FINAL SUMMARY REPORT
Yucca Pens Hydrologic Restoration Plan
Task 1: Summary Report and Metadata
(Work Order No: 4600000893-WO03)

August 12, 2009
08006.02

This report presents the findings of Task 1. A draft copy of this Task 1 report dated July 1, 2009 was submitted to the Interagency Deliverable Review Team (IDRT) members for their review. The comments from the IDRT members along with the response to these comments are presented in Appendix D. The Task 2 report will be prepared at a later date.

Figure 3-1
 08006.02A

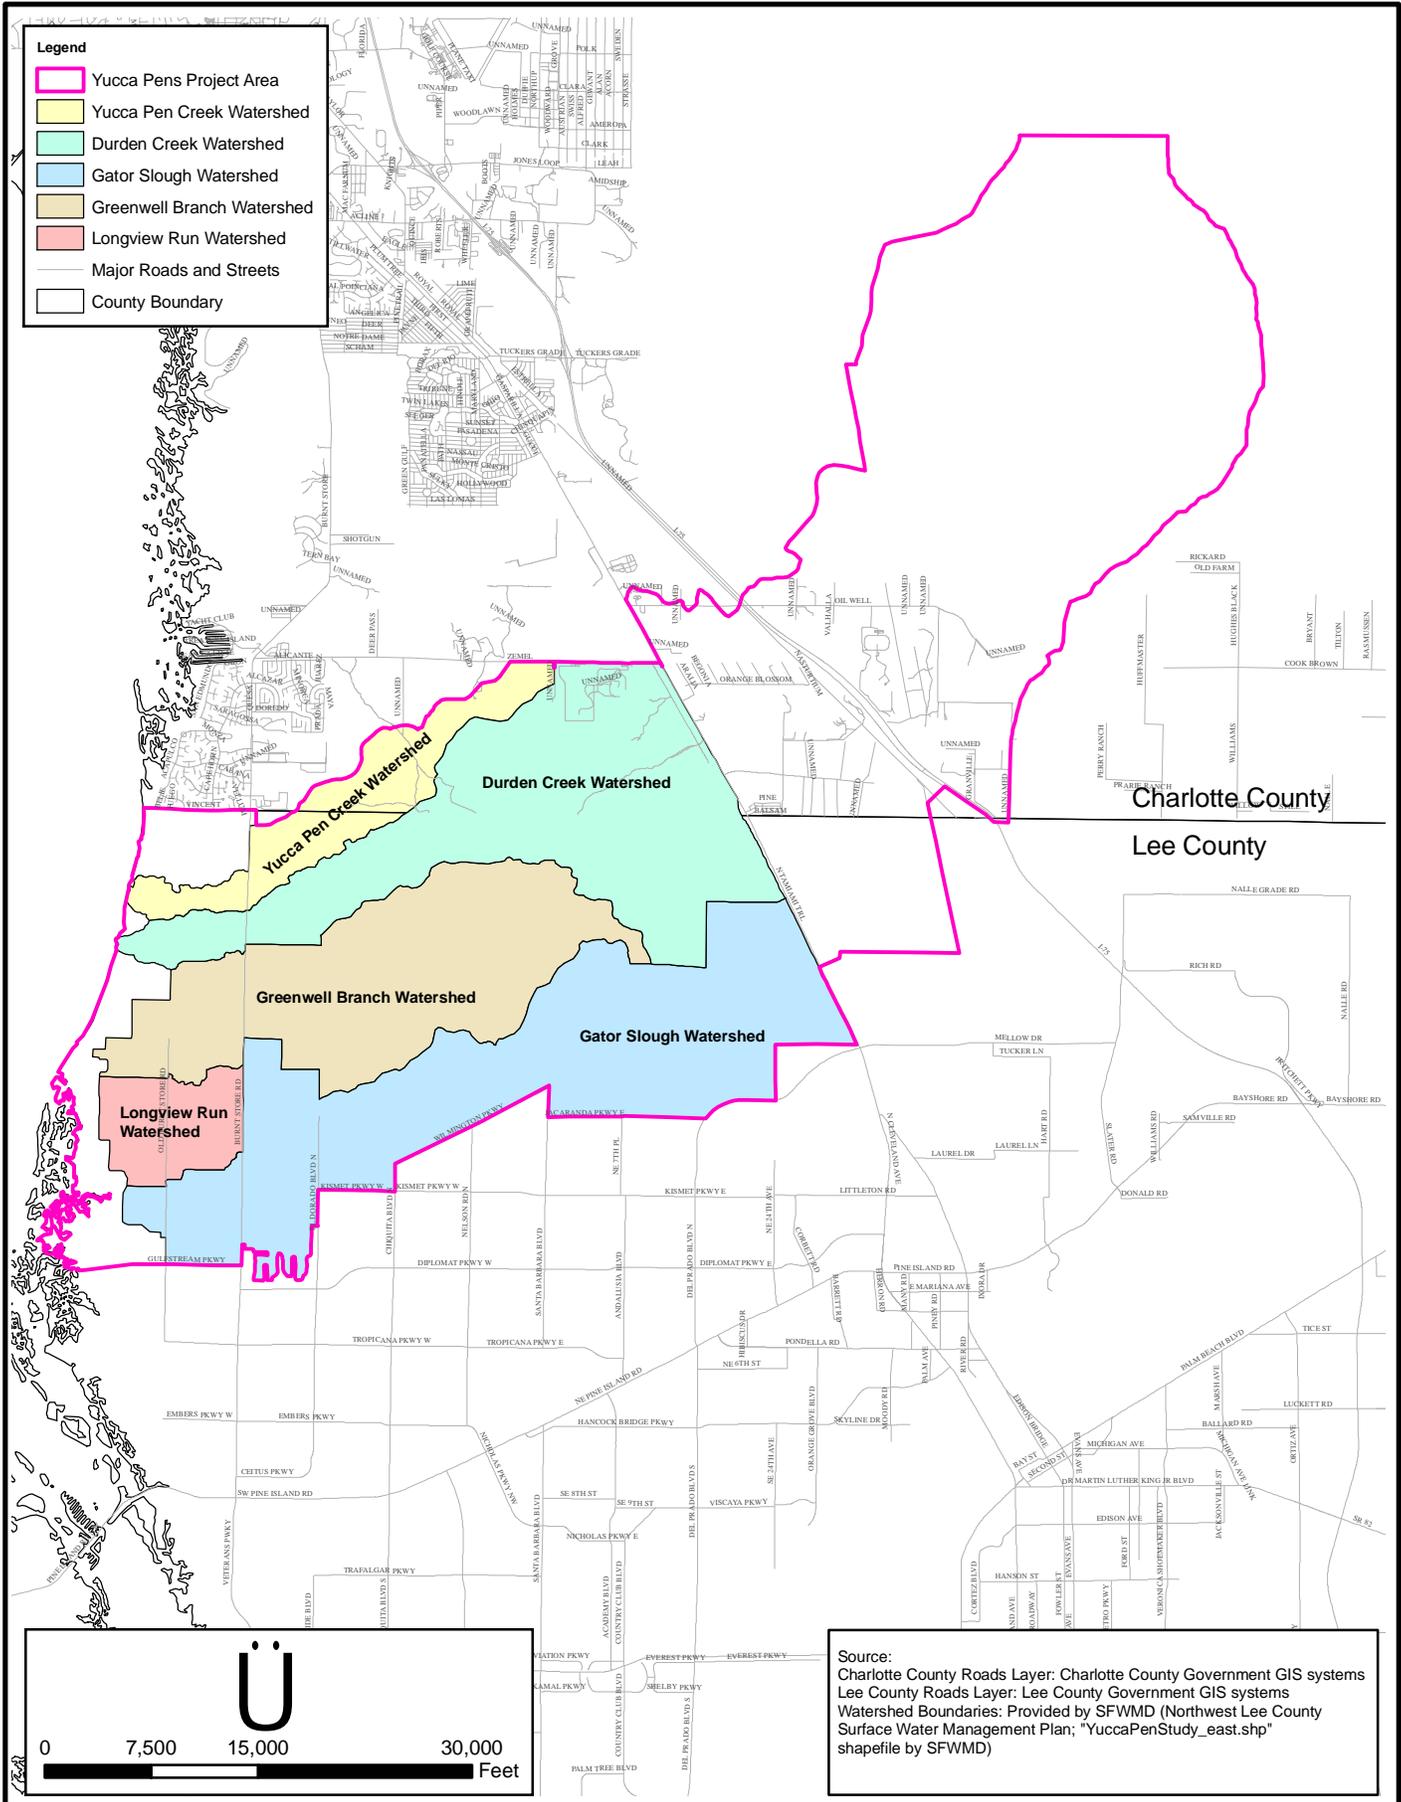
3.1.1, 7, 24	Comment on 5/28/09 Draft Report - Check the south boundary of fig 3-1 east of I-75	Anura Karuna-Muni/Lee County Natural Resources	The consultant will check this.
